CMD 19-M24.7

**Written submission from
Lake Ontario Waterkeeper
and Ottawa Riverkeeper**

**Regulatory Oversight Report for
Canadian Nuclear Laboratories
(CNL) sites: 2018**

**Re: 2018 CNSC Staff Regulatory Oversight Report Meeting
concerning Canadian Nuclear Laboratories Sites**

Figure 1. CRL site description indicating potential source facilities as given in (A) the Annual Safety Report 2016 by CNL, (B) Environmental Risk Assessment 2019 by CNL, and (C) this study by the author.

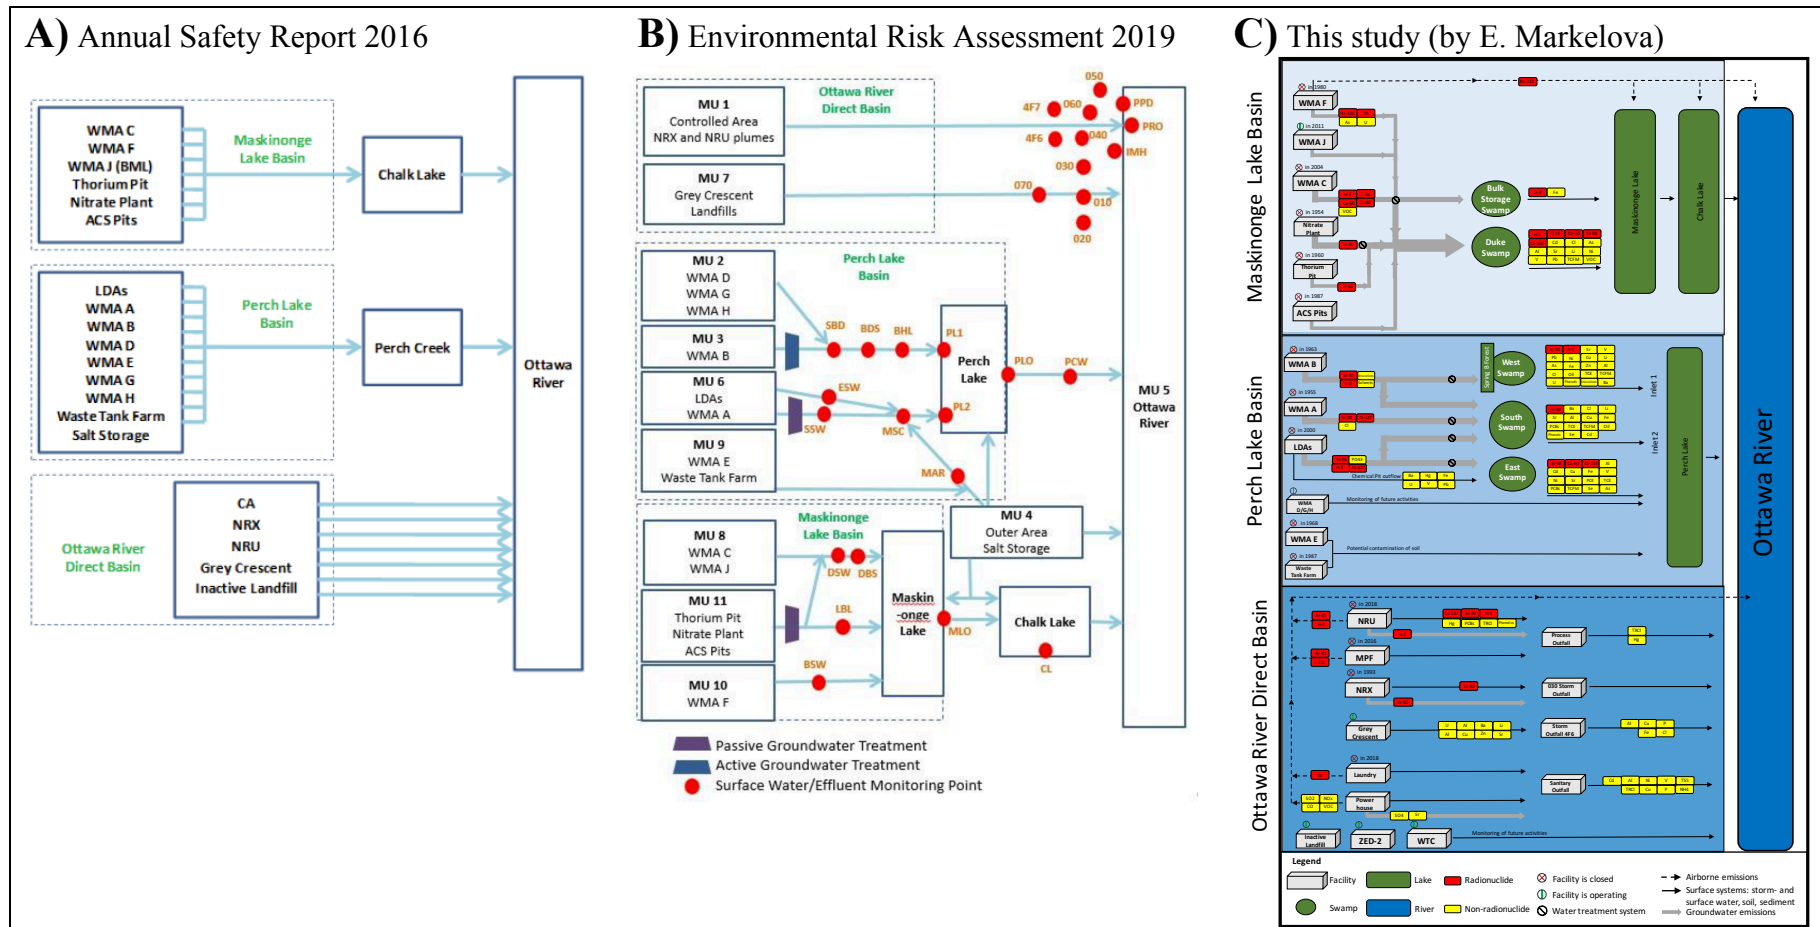
There are two types of CRL site characterization with regard to its environmental impact. The first type is based on the grouping the facilities and discussing associated contamination per each watershed separately (i.e., 3 areas). This approach is implemented by the Canadian Nuclear Laboratories (CNL) to report the environmental performance review within the Annual Safety Report. The second type is more recent and detailed, which organizes the CRL site into 11 Management Units (MU) (i.e., 11 areas). In turn, this study aimed to supplement both approaches and provide detailed information on contaminant pathways through groundwater, surface water and atmosphere discussed in 11 MUs, while combined in 3 watershed areas. The schematics of all these approaches are given in Figure 1.

Figure 4. Schematic of potential source facilities of CRL within the Perch Lake Basin prepared by the author of this study based on the Environmental Risk Assessment 201

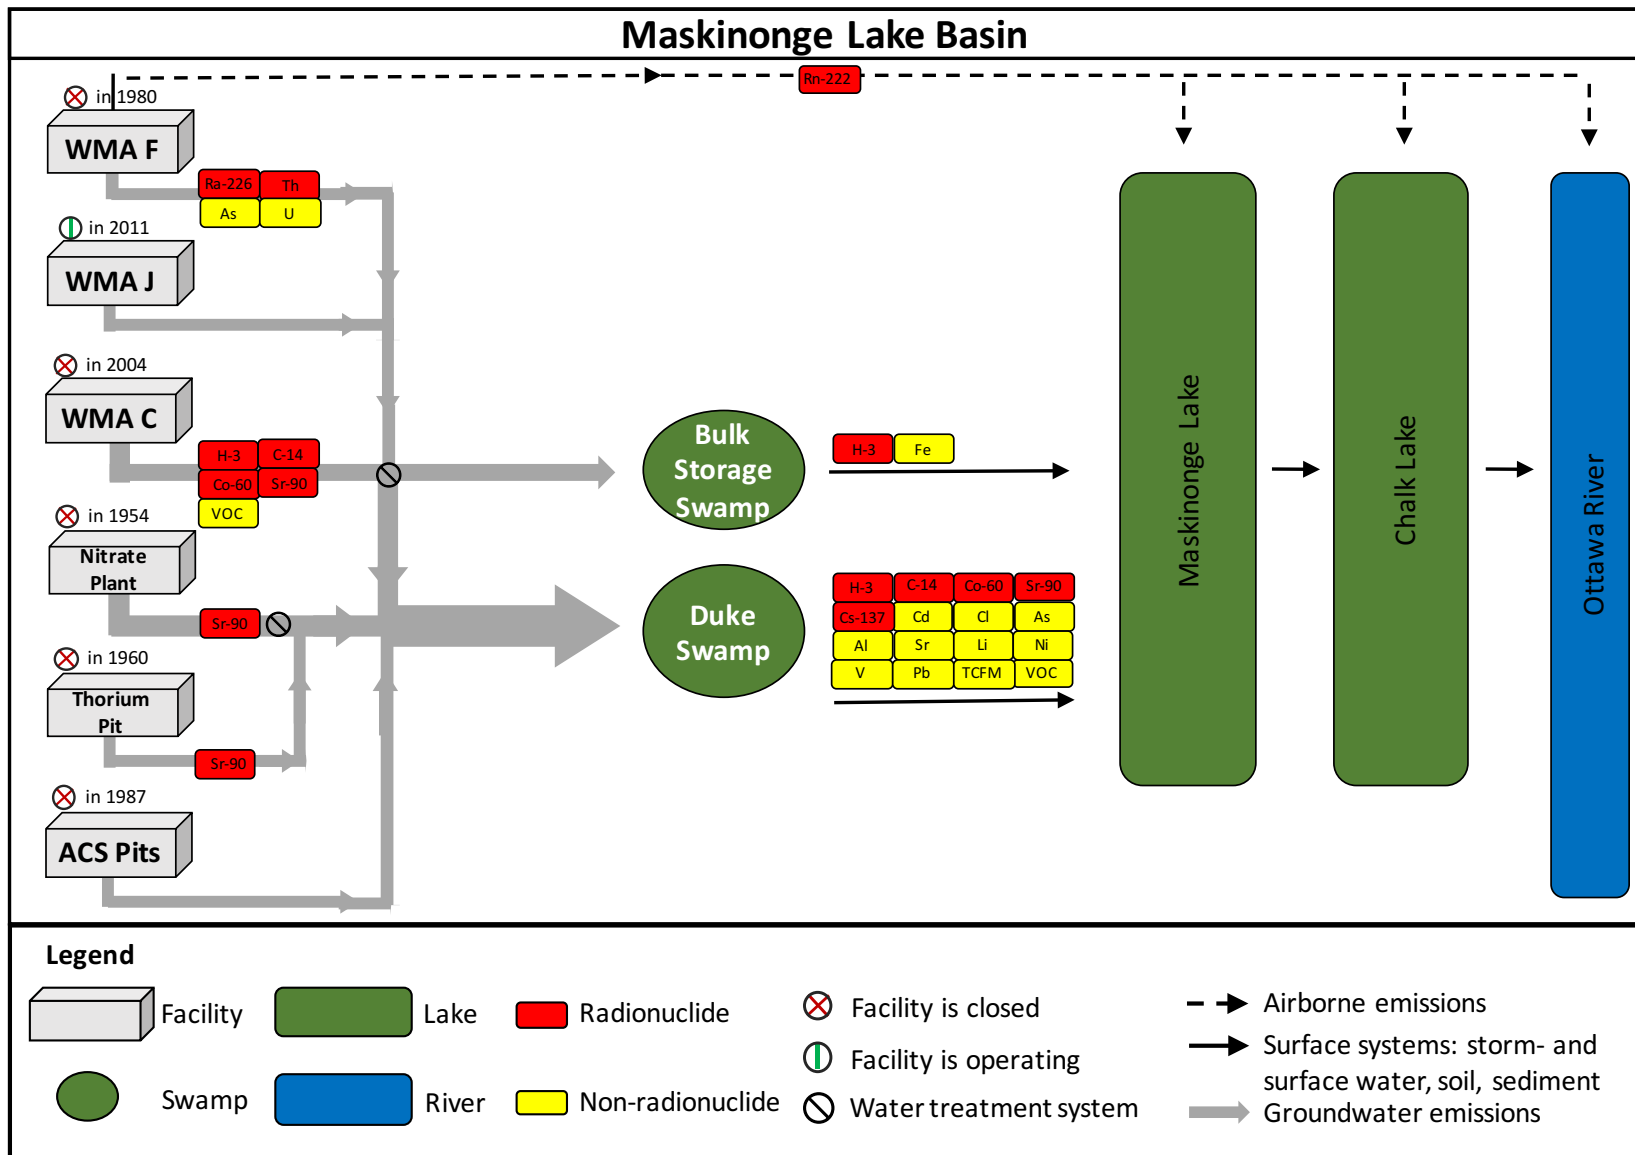
Schematics of contaminant pathways through major facilities	Figure 3 represents the schematics that was constructed within this review to visualize the contaminant pathways through major facilities of the Perch Lake Basin.
